SUBJECT: Addendum No. 4

RE: Invitation to Bid (ITB) Solicitation No. H93-IAHDRR-2024-026, IAH Terminal D Restroom Renovation at Multiple Gates at George Bush Intercontinental Airport (IAH); Project No. 971

IAH Terminal D Restroom Renovation at Multiple Gates at George Bush Intercontinental Airport (IAH)

This revision is a clarification of fixtures, finishes and MEP changes. All sheets now show the TIP/BSG numbers on the TTB. This clarification involves the following documents:

SHEET NAME: CONSTRUCTION PHASING PLAN
SHEET No. G-022 SCALE: As indicated
SHEET SIZE: 30"x42" ARCH E1

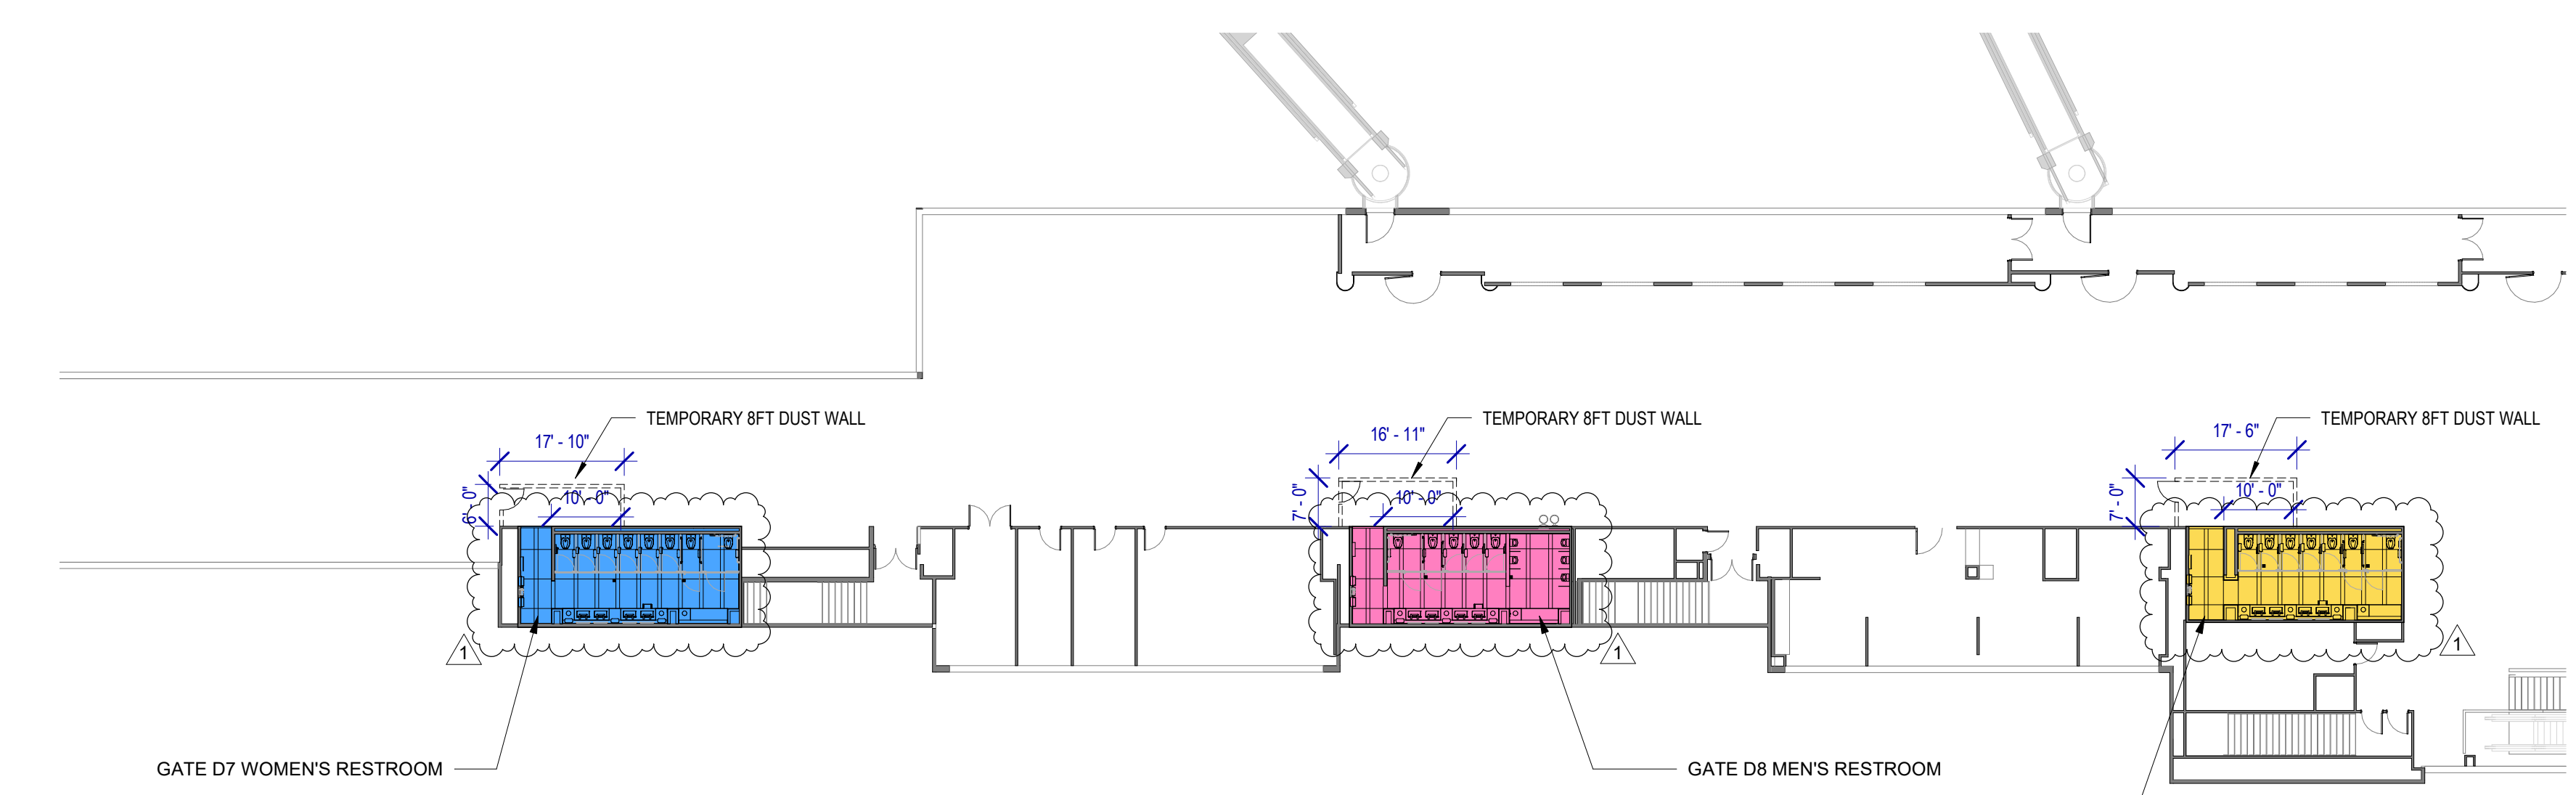
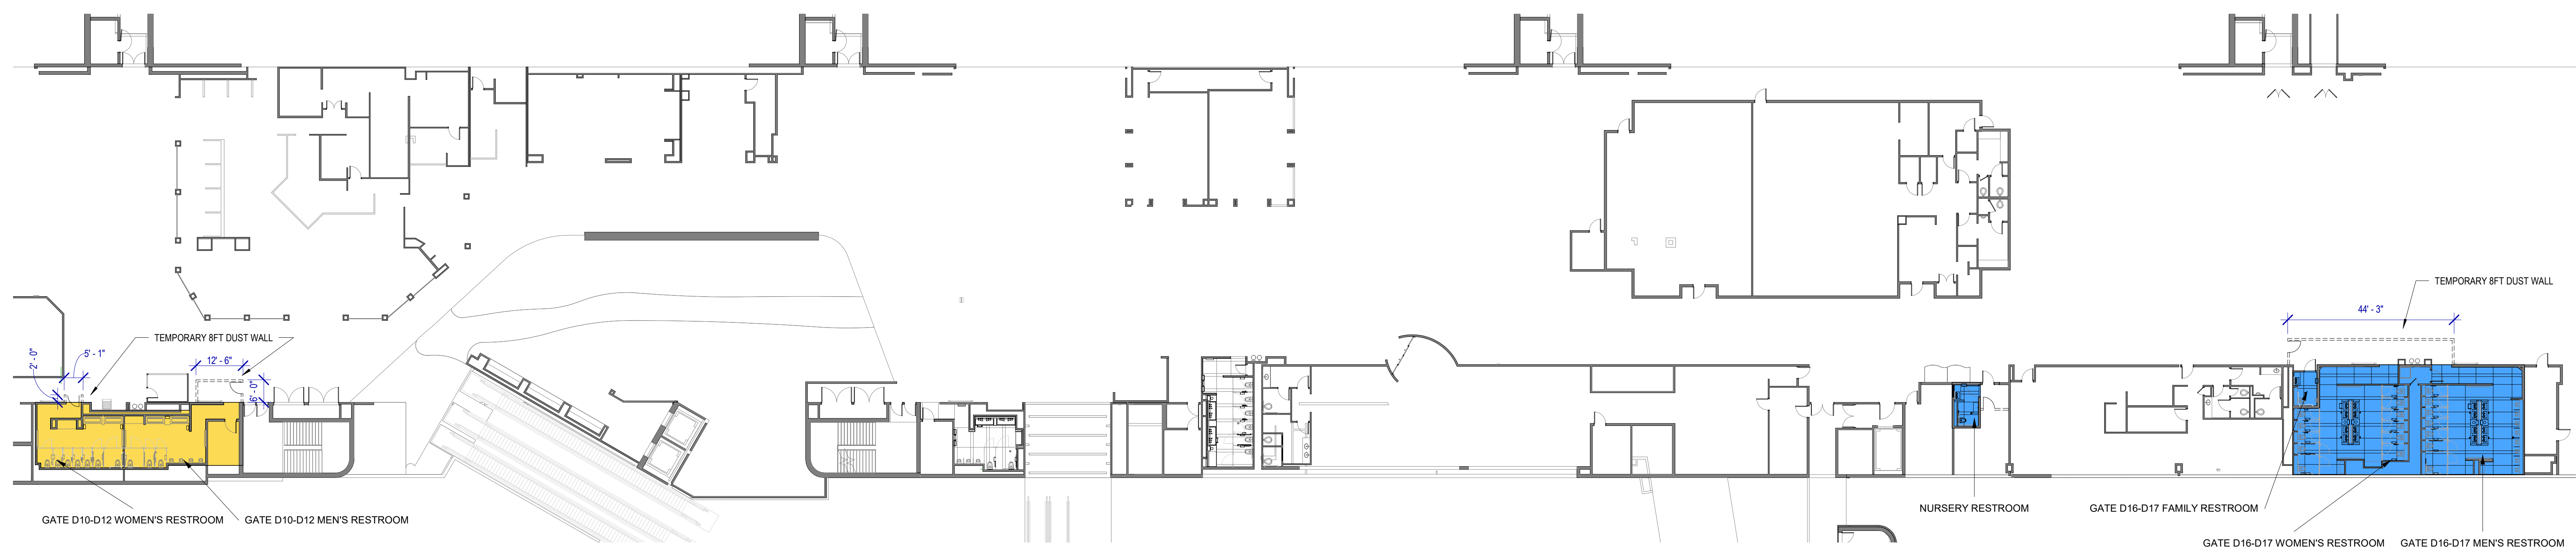
G-022: new Construction phasing for restrooms at CD Connector. Revised Construction Phasing notes.

SHEET NAME:
ENLARGED RR RCP PLANS - TERMINAL D
SHEET No. A-142 SCALE: 1/4" = 1'-0"
SHEET SIZE: 30"x42" ARCH E1

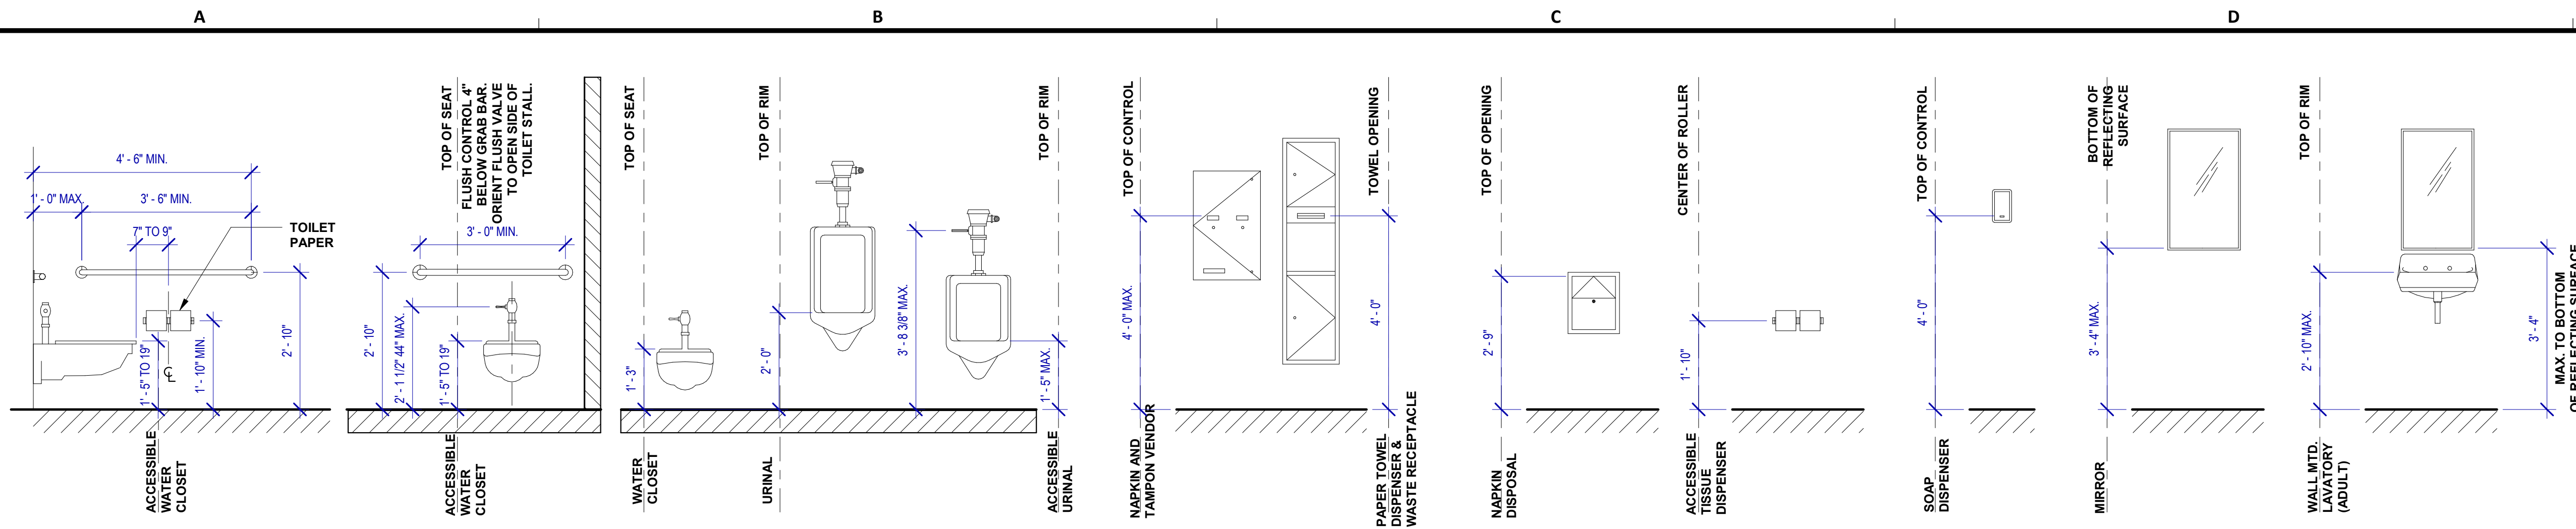
A-142: revised light fixtures layout.

SHEET NAME: TYPICAL ELEVATIONS AND PLANS
SHEET No. A-420 SCALE: As indicated
SHEET SIZE: 30"x42" ARCH E1

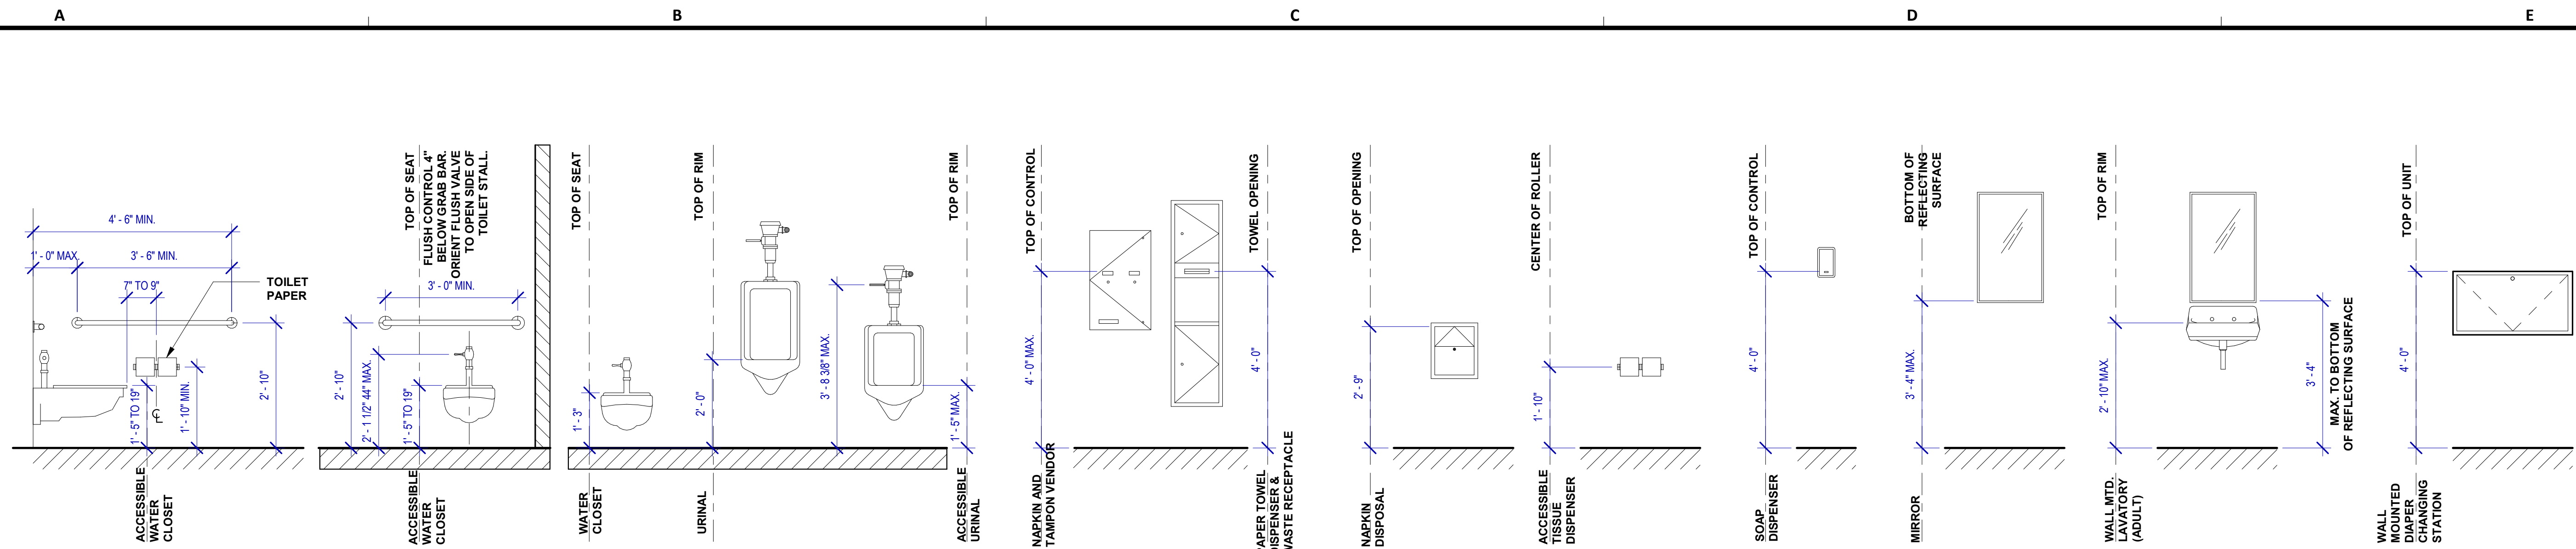
A-420: revised Typical Lavatory elevations & Plumbing fixtures legend.

SHEET NAME: WOMEN'S RESTROOM ELEVATION - GATE D07
SHEET No. A-427 SCALE: As indicated
SHEET SIZE: 30"x42" ARCH E1

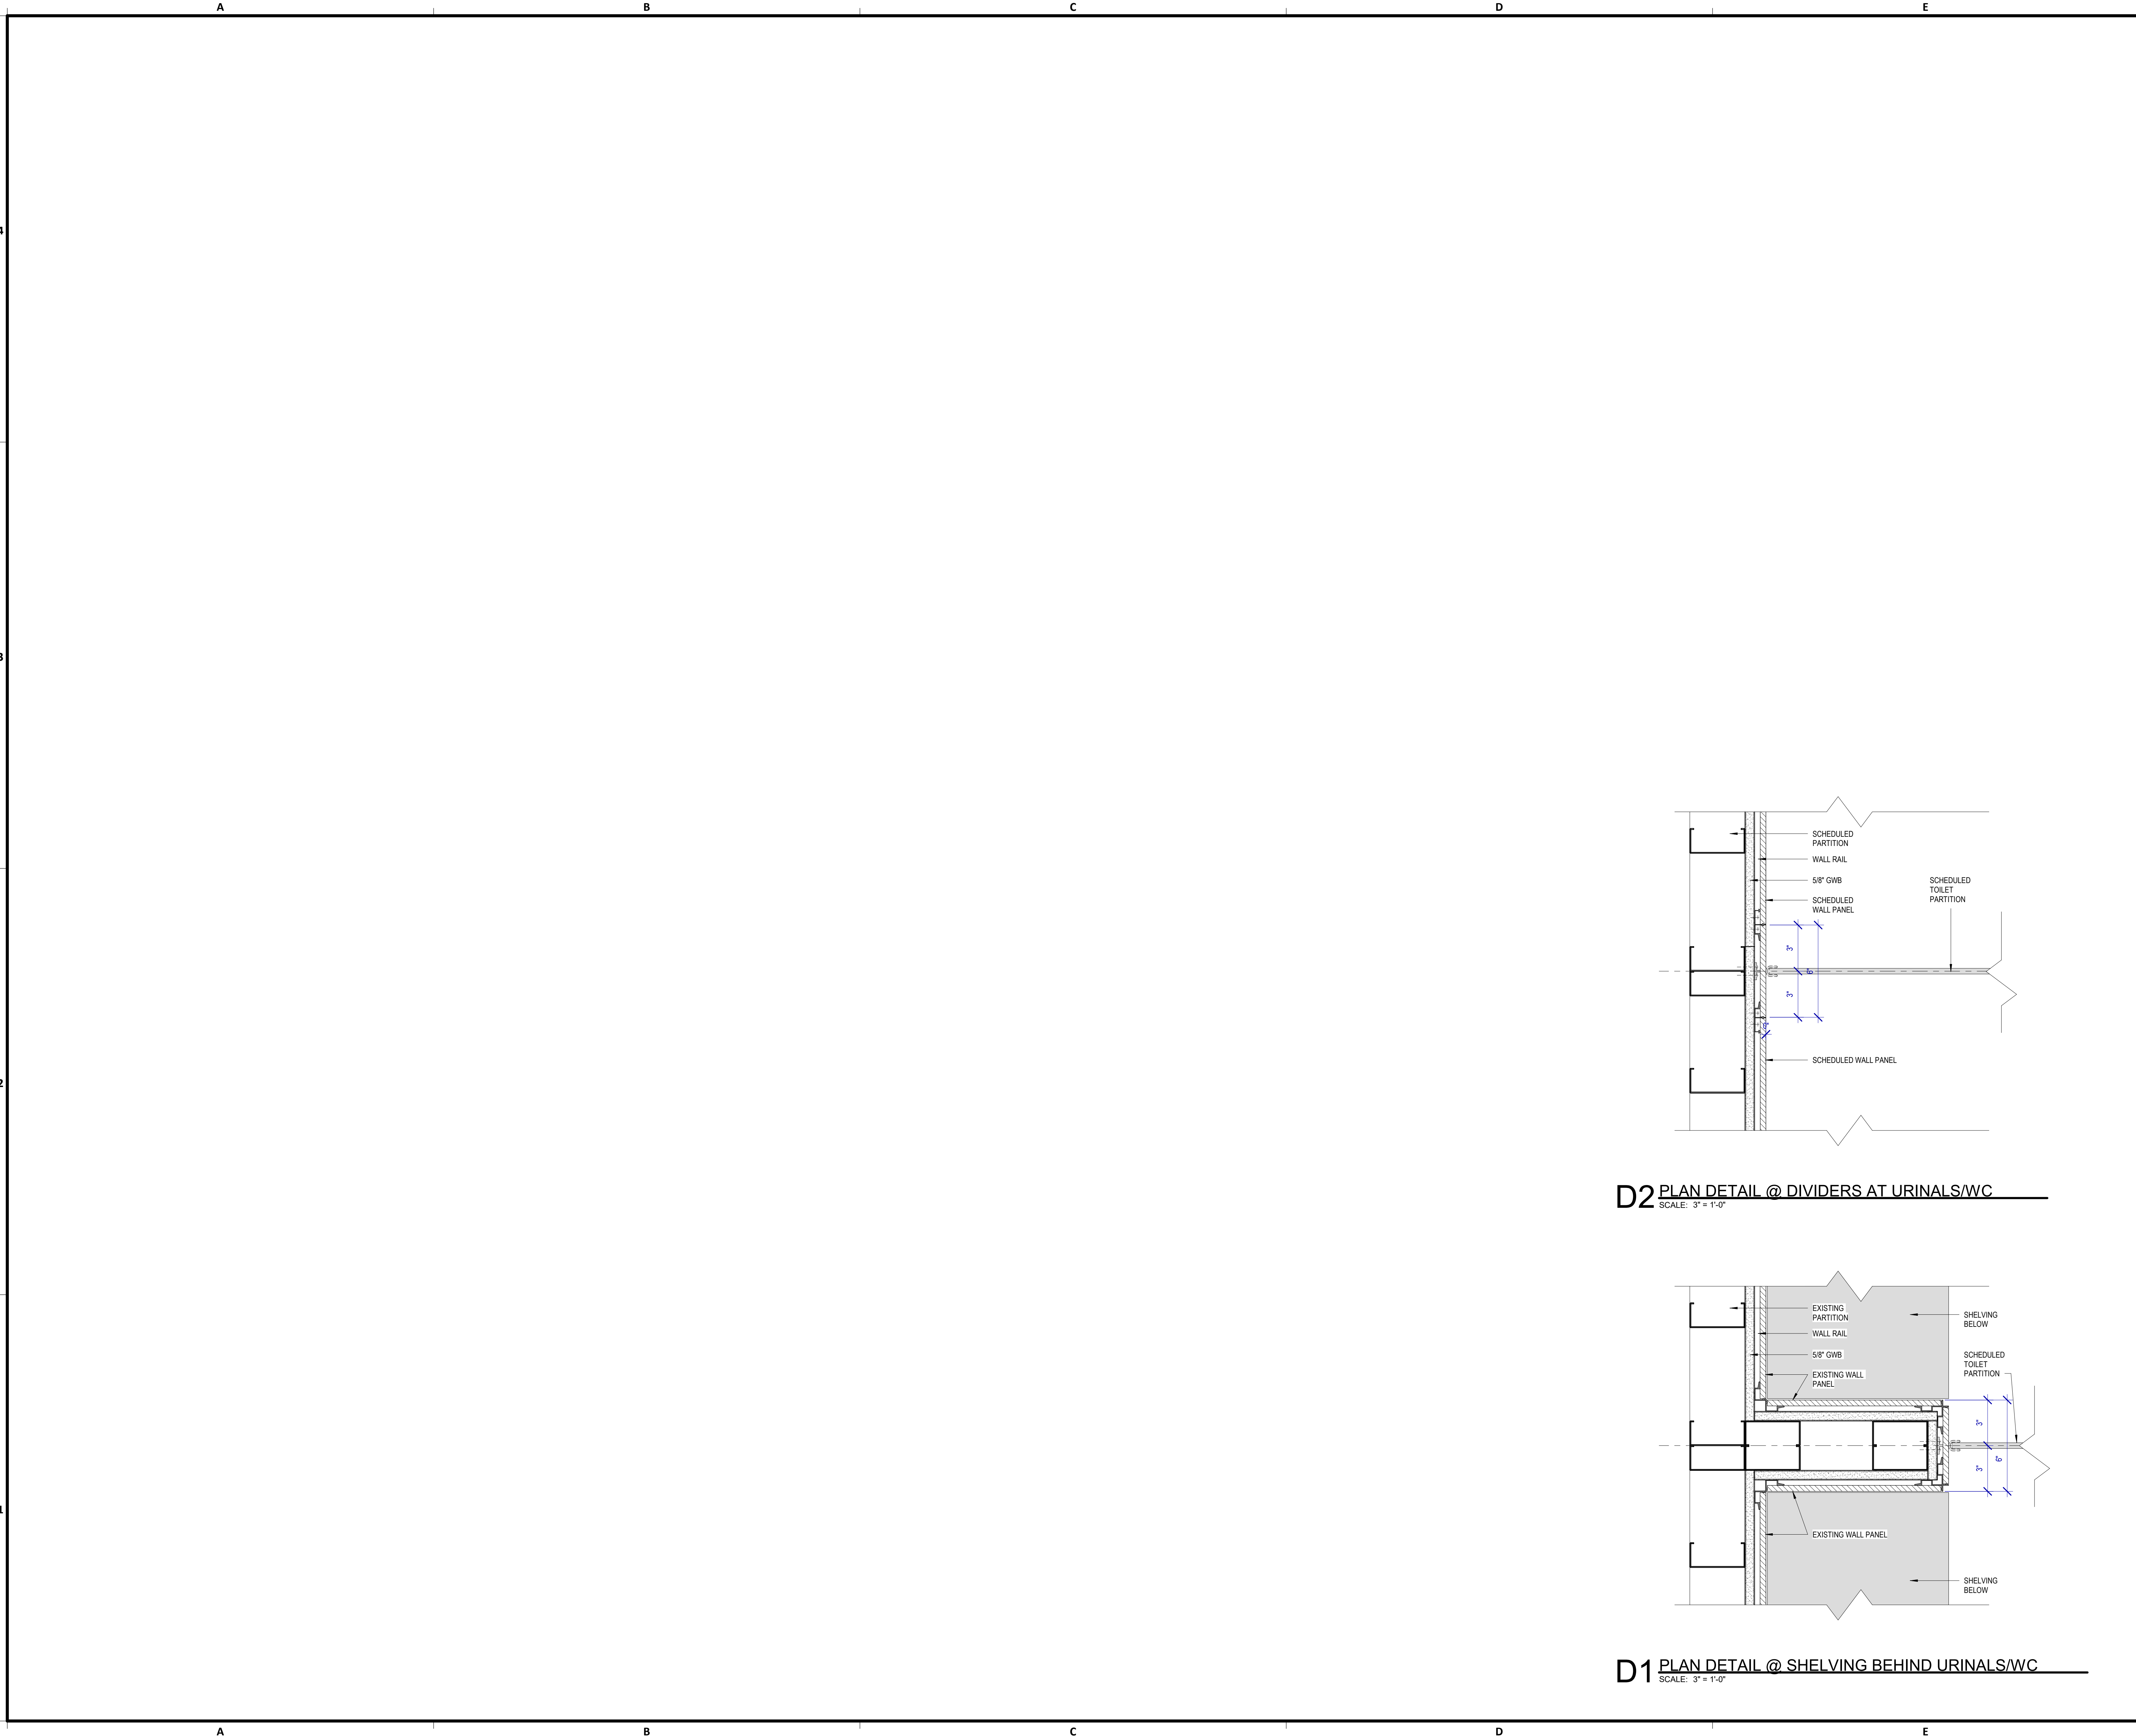
A-427: revised tags, dimensions & Plumbing fixtures legend.
